APPLICATION NO.	FILING DATE	FIRST NAMED INVENTOR	ATTORNEY DOCKET NO.	CONFIRMATION NO.
10/602,784	06/24/2003	Basil C. Linton	ITW-13971	1672

Office Action Summary

DETAILED ACTION

FIG. 1

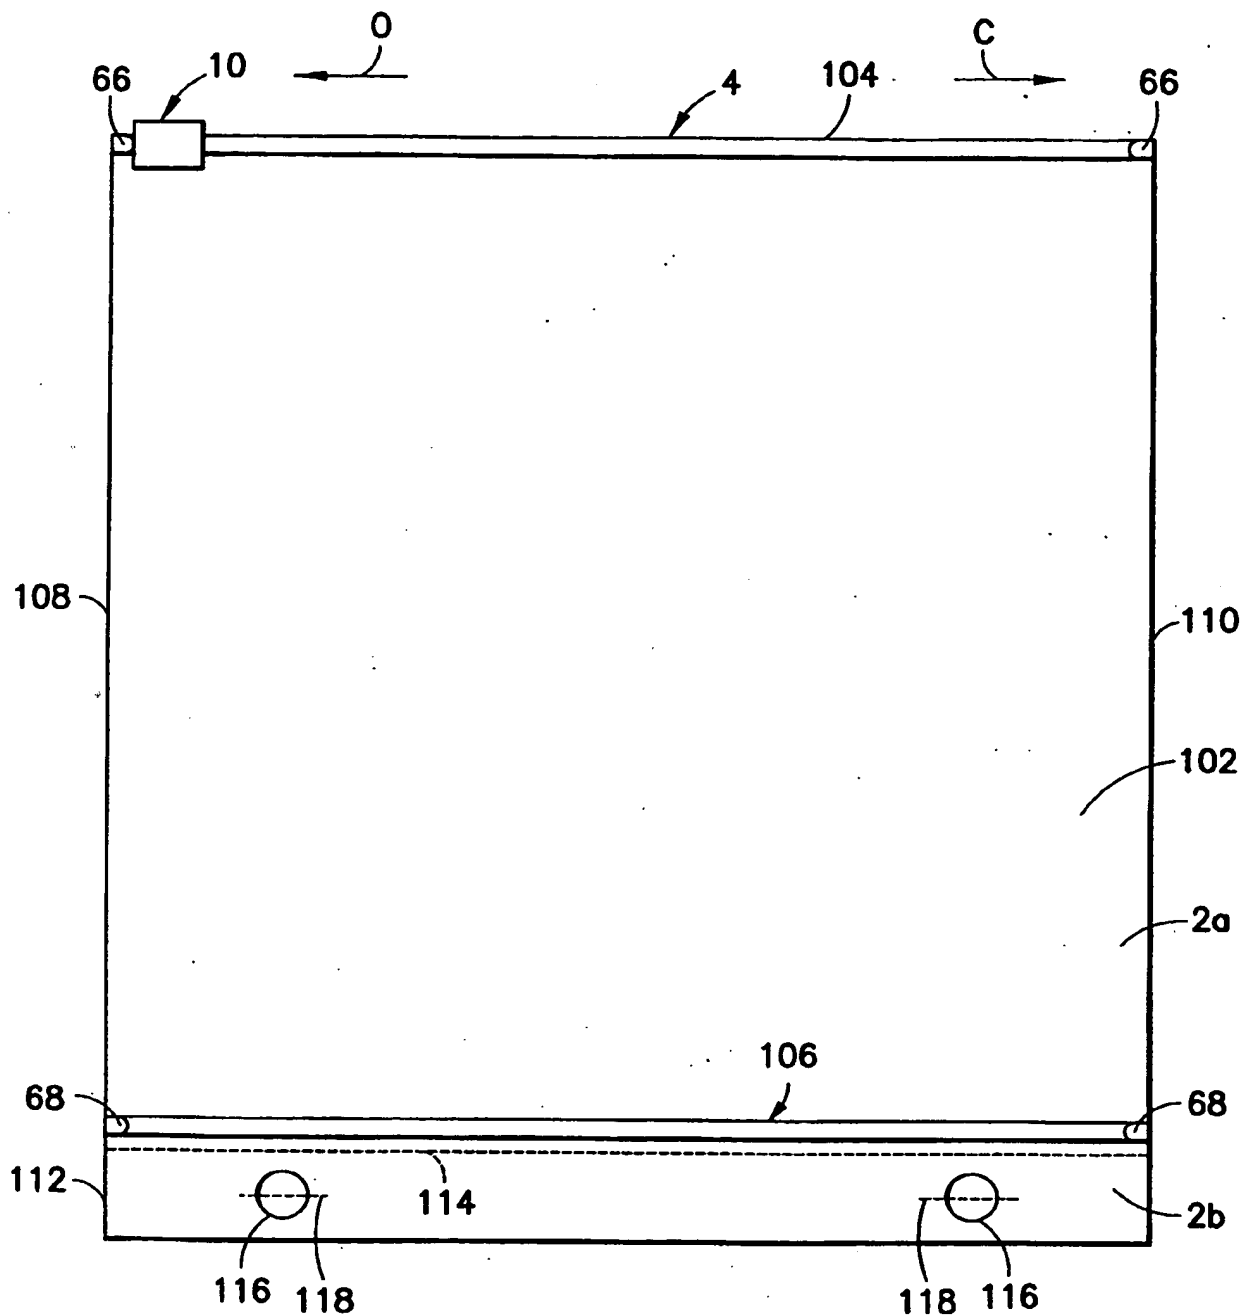
1. The drawings were received on March 25, 2005. These drawings are approved in part. The corrections to figure 3 is accepted. The changes to figure 1 introduces new matter since there is no support in the disclosure as originally filed to depict the slits with having the orientation illustrated. In fact, there is no disclosure for any length or orientation of the slits. Figure 1 is not approved.

2. In order to avoid abandonment, the drawing informalities noted in paragraphs 3 and 4 (relating to the slits) in the paper mailed on December 16, 2004, must now be corrected. Correction can only be effected in the manner set forth in the above noted paper.

not approved

FIG. 3

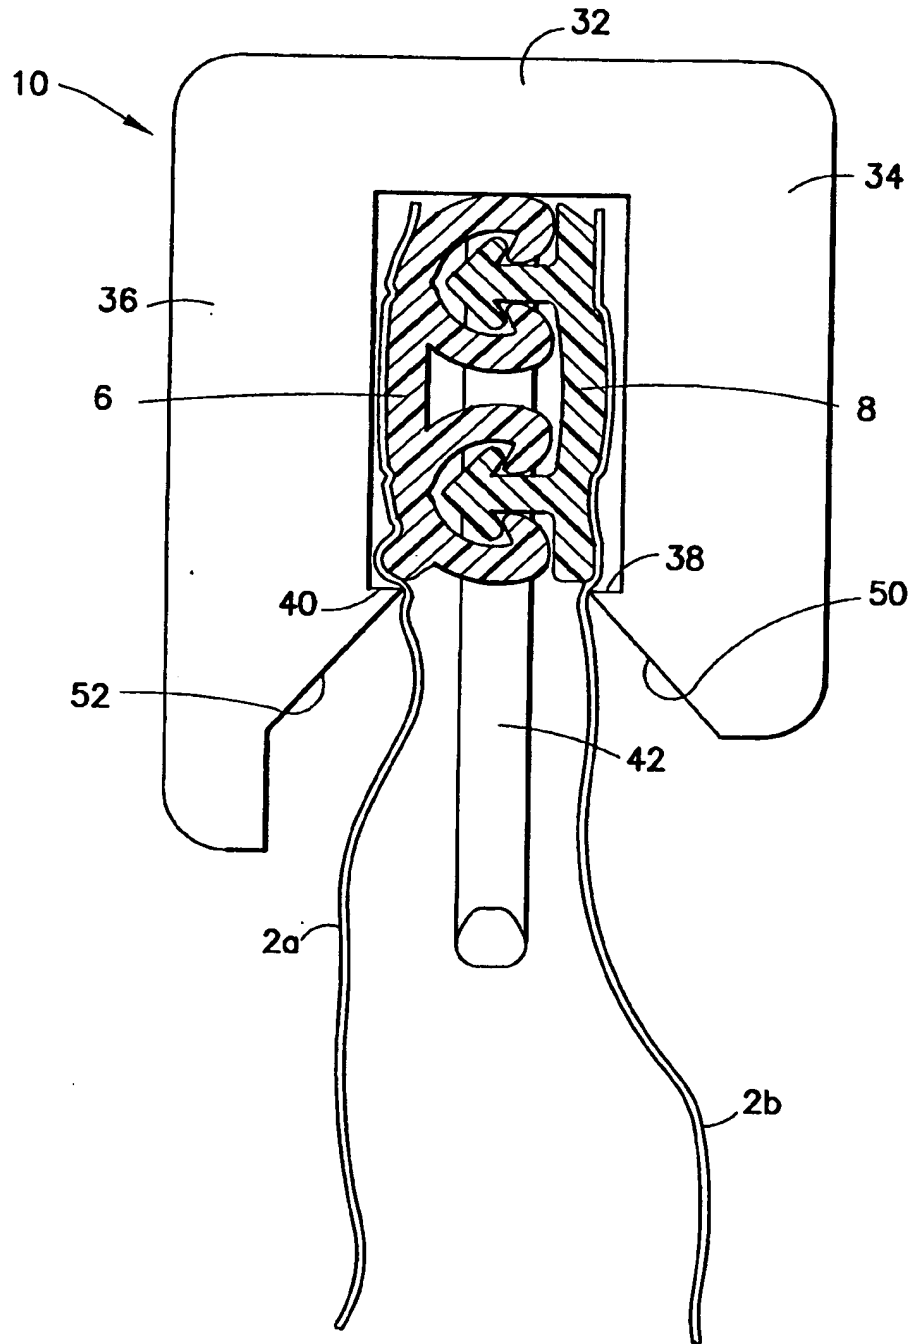
Approved
